BLOOMINGTON HISTORIC PRESERVATION COMMISSION

AGENDA

Summary:
Design for the construction of a new house and garage in the Prospect Hill Conservation District

COA-09-13

C O U N T R Y M A N + M A N S F I E L D H O U S E

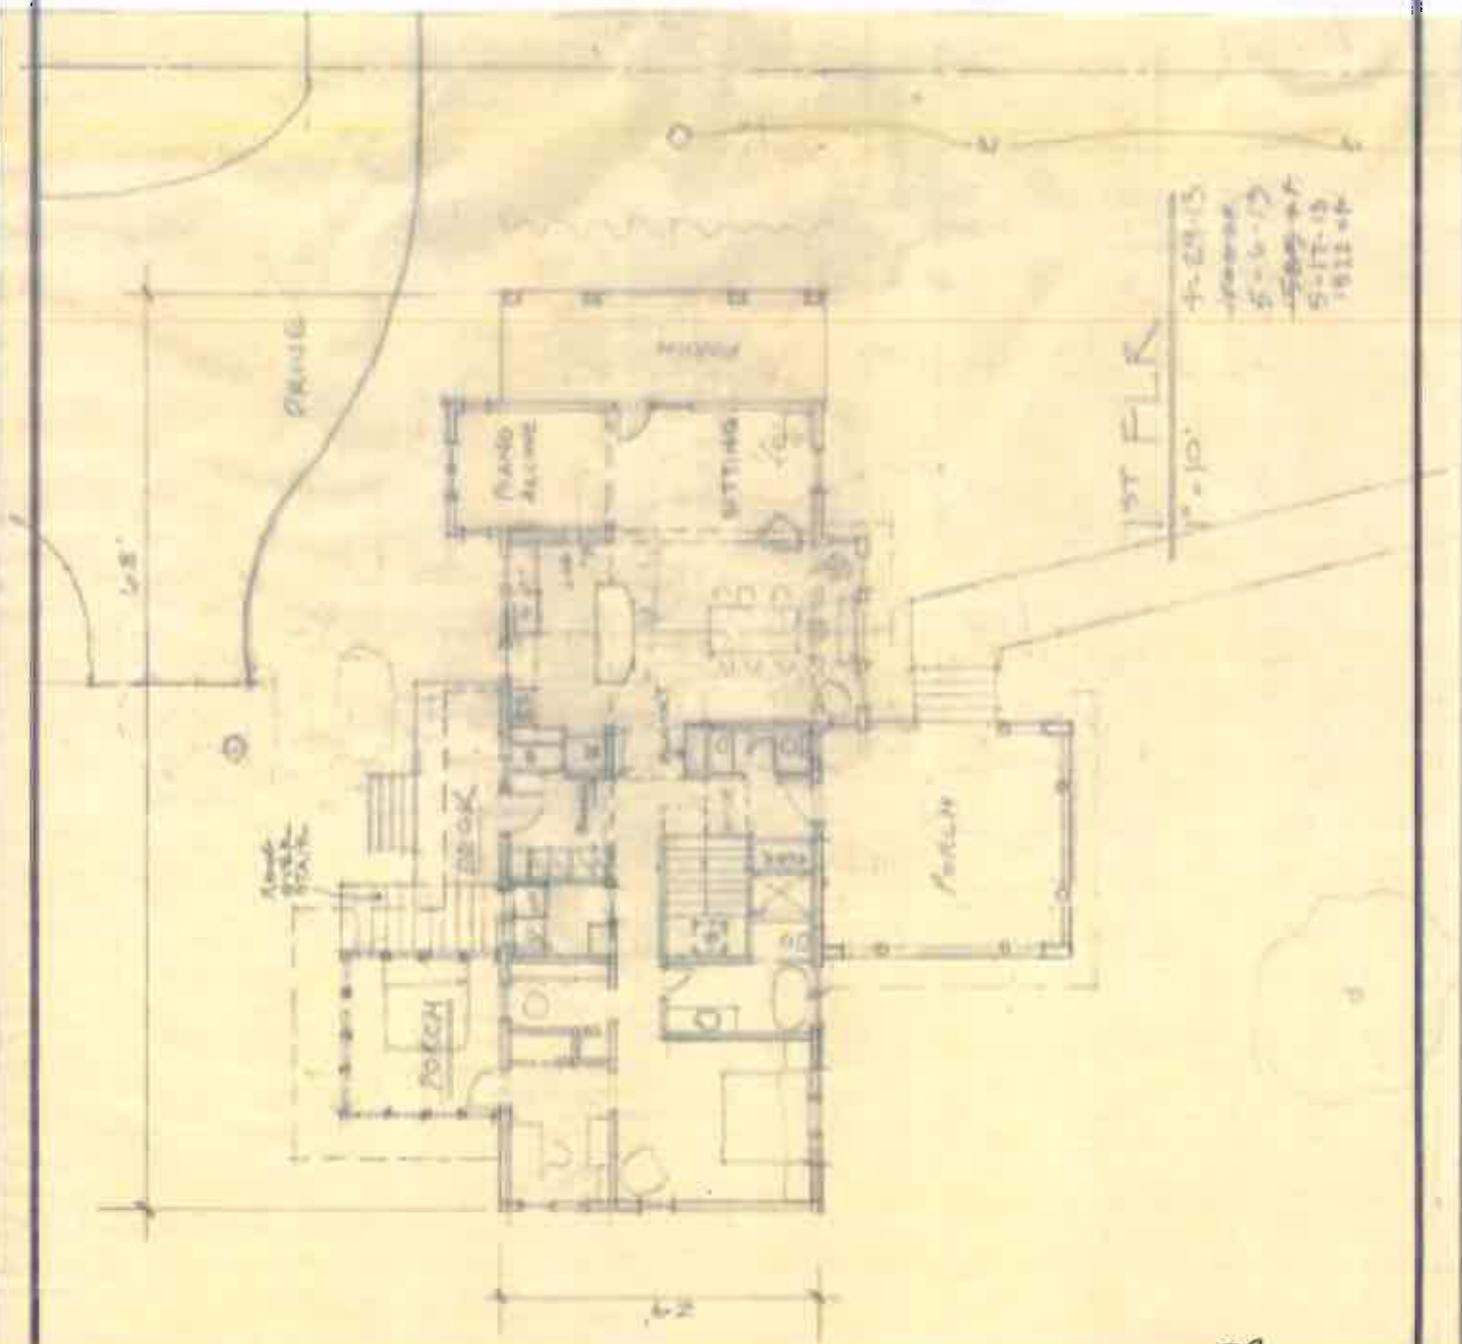
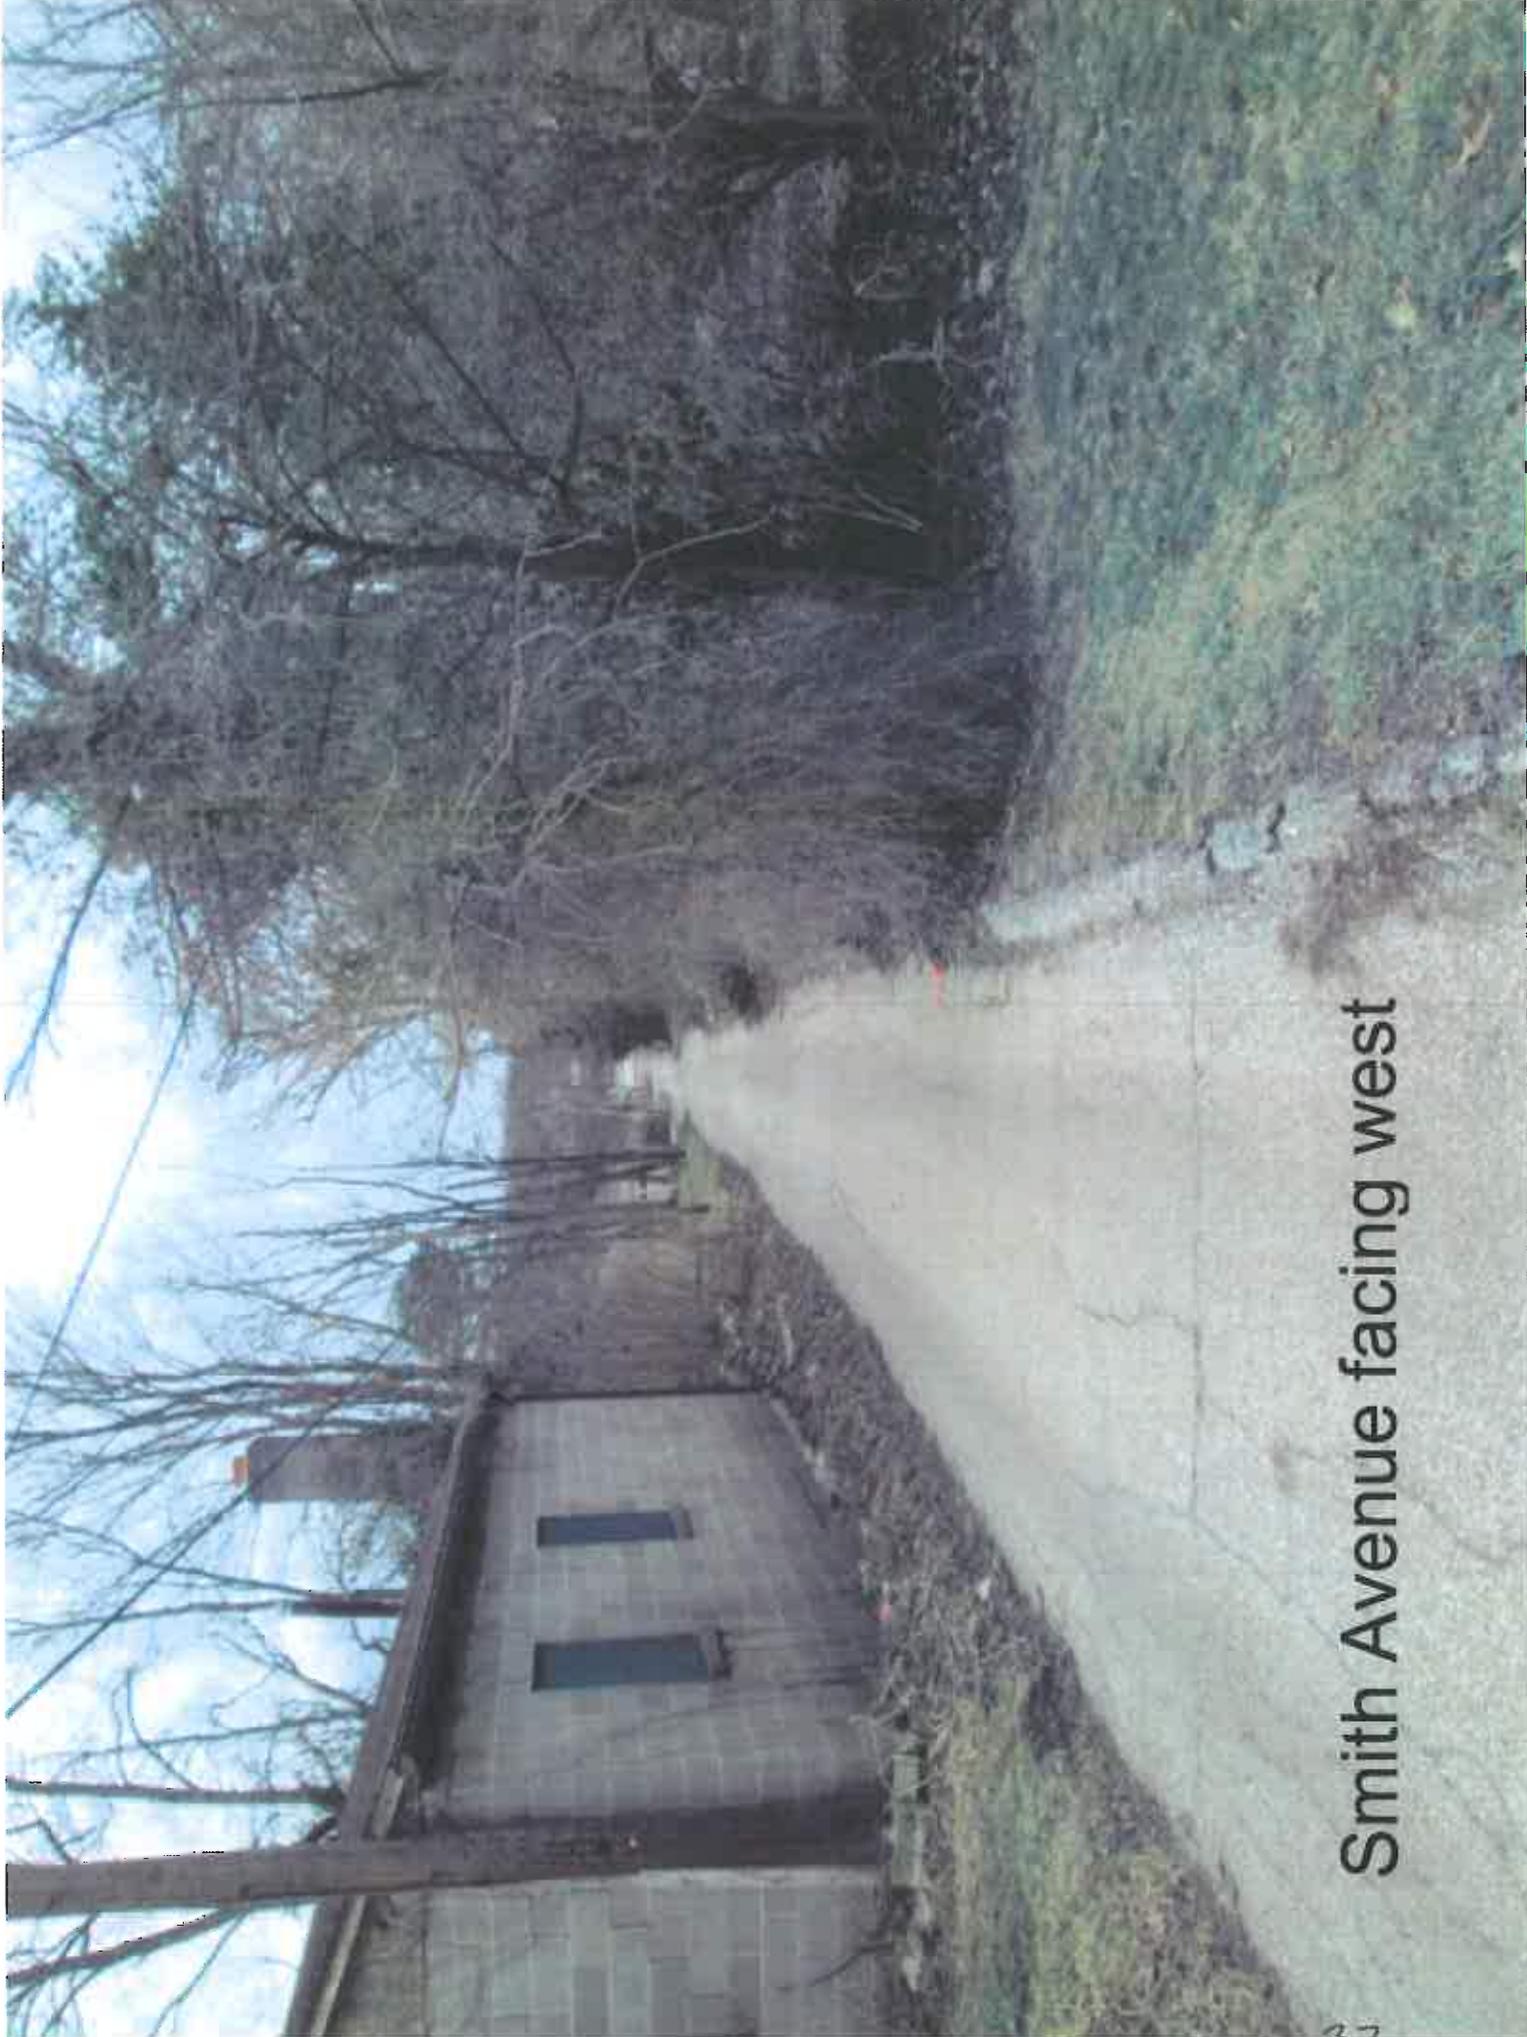
The owners met with the Prospect Hill Design subcommittee on May 29th and addressed comments, concerns and questions. The current design is a result of that dialogue. Here is a response from the owners.

With your suggestions in mind, we have redesigned elements of the porch as follows:

1. The artsy trees have been removed to better reflect the open design of the porches in Prospect Hill. This also increases visibility of the front door.
2. The vertical panels are now shown as two distinct parts (porch and base) via a space between the porch floor and the bottom of the railing. This spacing is also a common feature in Prospect Hill porches.

3. Although it is not shown in the drawing, the panels have spacing between them which also increases visibility of the front door from Smith. Please see the

Staff recommends approval but invites discussion of the least obtrusive way to allow a pull off parking space on Smith.
